OYSTER CREEK NUCLEAR GENERATING STATION, UNIT NO. 1

AMENDMENT TO PROVISIONAL OPERATING LICENSE

Amendment No. 30
License No. DPR-16

SAFETY EVALUATION BY THE OFFICE OF NUCLEAR REACTOR REGULATION
SUPPORTING AMENDMENT NO. 30 TO PROVISIONAL OPERATING LICENSE NO. DPR-16
JERSEY CENTRAL POWER AND LIGHT COMPANY
OYSTER CREEK NUCLEAR GENERATING STATION
DOCKET NO. 50-219

FIGURE 3.10.1

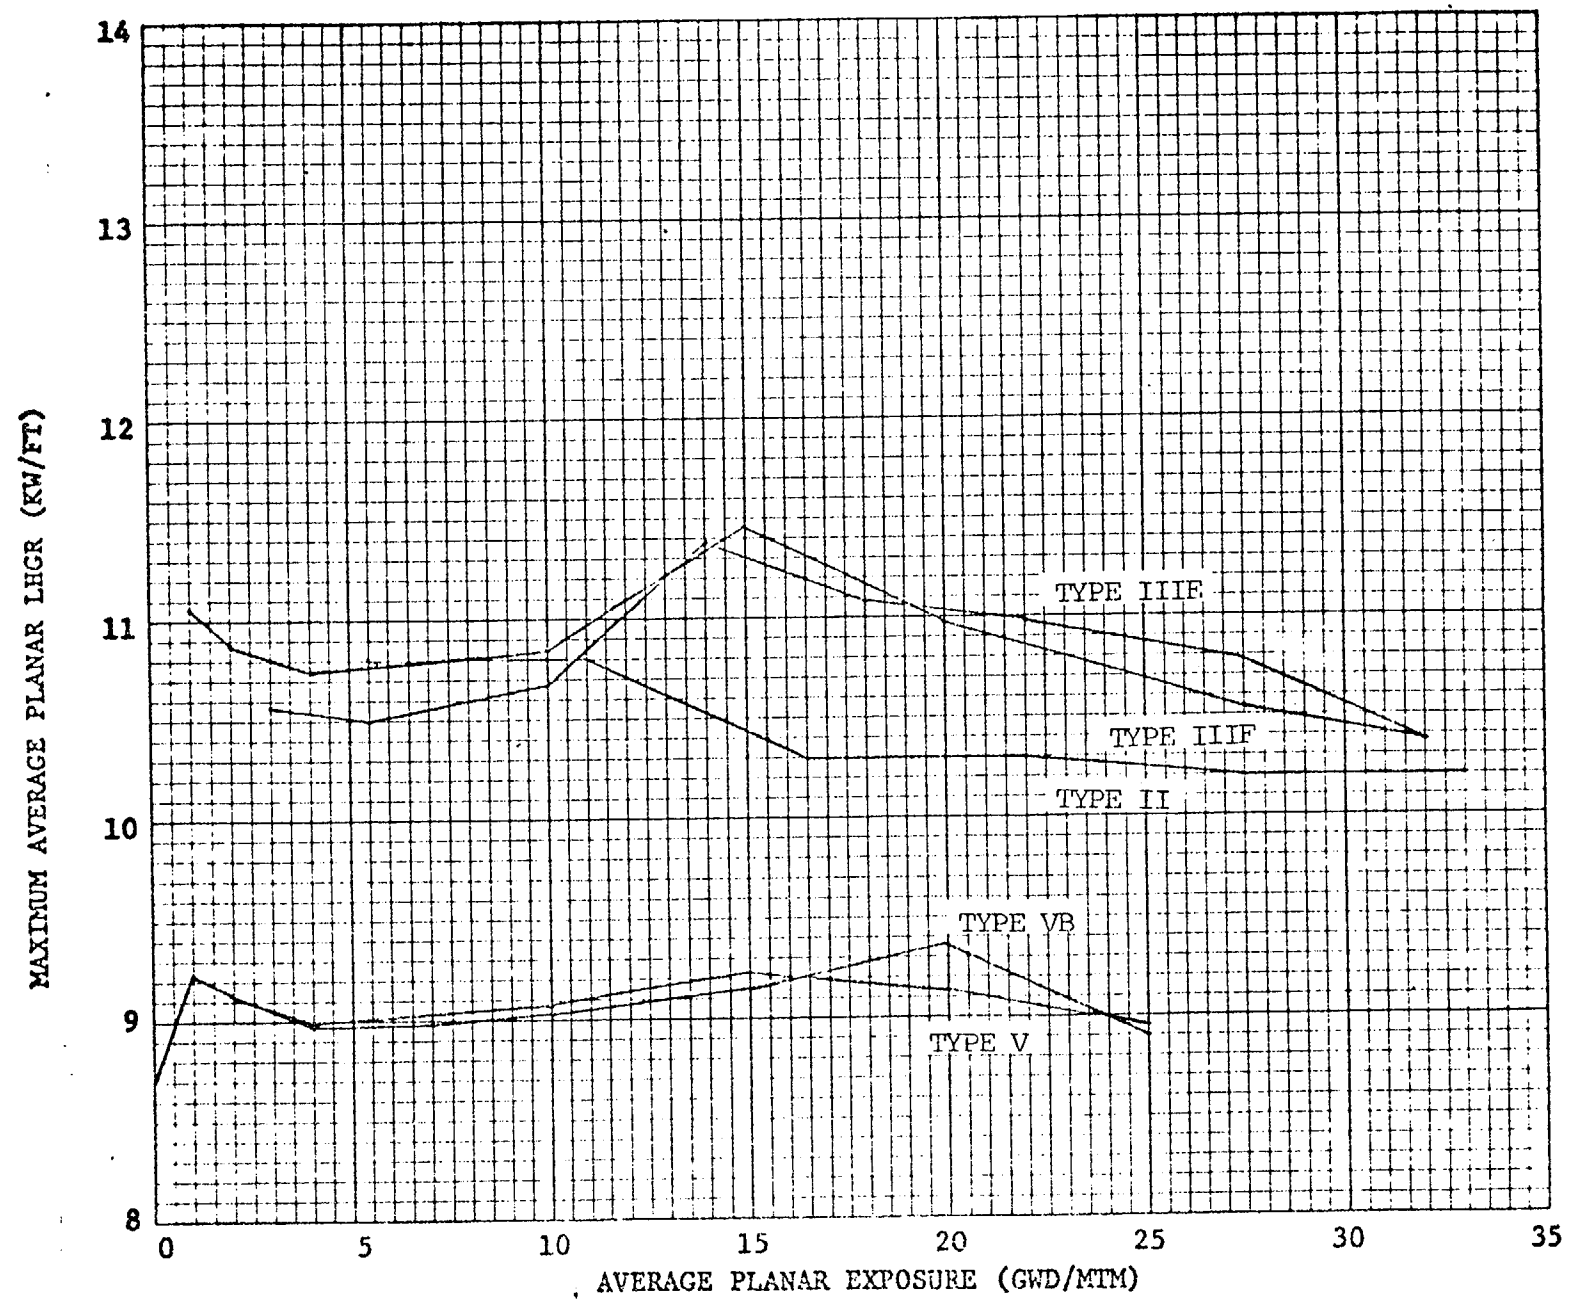
The proposed amendment would extend the MAPLHGR specification for fuel types currently in the core by modifying Figure 3.10.1. This modification extends the calculated MAPLHGR from 27.5 GWD/MTM (thousand megawatt days/metric ton) to 32 GWD/MTM for fuel types III E and III F, and from 20 GWD/MTM to 25 GWD/MTM for fuel types V and V B. The calculated MAPLHGR for fuel type II is not changed.

The proposed extensions of MAPLHGR shown in Figure 3.10-1 are based on an analysis using an approved ECCS evaluation model in agreement with Appendix K to 10 CFR Part 50. This analysis, performed by

We have reviewed the proposed changes and have concluded that they are based on calculation methods previously accepted; they do not change MAPLHGR limits previously found acceptable but only extend the previous calculations to higher fuel exposures and therefore are acceptable.
